**CITY PLAN COMMISSION**

**FILE NUMBER:** S234-158

**REQUEST:** An application to create one 1.164-acre lot from a tract of land in City Block 6526 on property located on Fabens Road, east of Ables Lane.

**LOT 169A, BLOCK 6526  
FABENS ADDITION**

**PRELIMINARY PLAT**

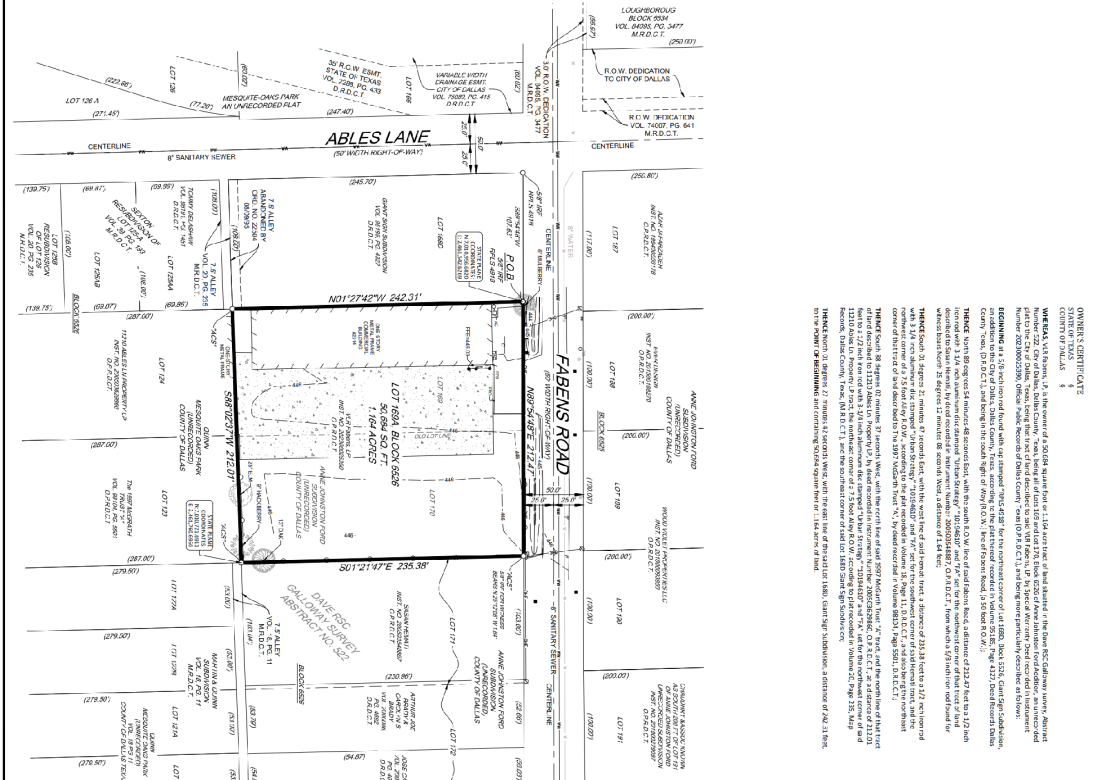
12. Submit a full set of Civil Engineering Plans (drainage, paving, street signage/markings/lighting) prepared per City Standards by a licensed (TX) Professional Engineer to Engineering Division in Room 200, Oak Cliff Municipal Center (i.e. 311T/DP). Additions and alterations to the public infrastructure require approval and may require private development contracts with bonds.51A-8.102 (c); 8.601(b)(4),(5),(6),(7),(8),(9)
13. Detention may be required if the capacity of available outfall is not adequate to carry the developed runoff. Section 51A-8.611(c).
14. Place a note on the final plat stating "Lot-to-Lot drainage will not be allowed without proper City of Dallas Engineering Division approval" 51A 8.611(e)

15. Prior to final plat, submit a completed final plat checklist and all supporting documents.
16. On the final plat, show how all adjoining right-of-way was created. Section 51A-8.403(a)(1)(A)(xxii).
17. On the final plat, show recording information on all existing easements within 150 feet of the property.
18. On the final plat, show all additions or tracts of land within 150 feet of the property with recording information. Platting Guidelines.

19. Additional design information is required for assessment. Site plan must be submitted showing proposed development, building finished floor elevation, development, existing mains – including downstream manhole, and proposed water and wastewater service locations. Submit water/wastewater engineering plans to 320 E. Jefferson Blvd., Room 200, Attention: Water and Wastewater Engineering.

20. Wastewater main improvements may be required by Private Development Contract. Submit water/wastewater engineering plans to 320 E. Jefferson Blvd., Room 200, Attention: Water and Wastewater Engineering.

21. Prior to the final plat, show the Alley abandonment on the plat as follows: Abandonment authorized by Ordinance No.\_\_\_\_\_, recorded as Ins. Nos. (Cert. ORD No.\_\_\_\_\_, QCD No. \_\_\_\_\_). Utility Easements retained.
22. Prior to final plat, confirm if there was an abandonment in the platted area, and if so, please note accordingly on the plat
23. On the final plat, change “Fabens Road” to “Fabens Road (FKA Francis Street)”. Section 51A-8.403(a)(1)(A)(xii).
24. On the final plat, change “Ables Lane” to “Ables Lane (FKA Henry Road)”. Section 51A-8.403(a)(1)(A)(xii).
25. On the final plat, identify the property as Lot 169A in City Block 6526.
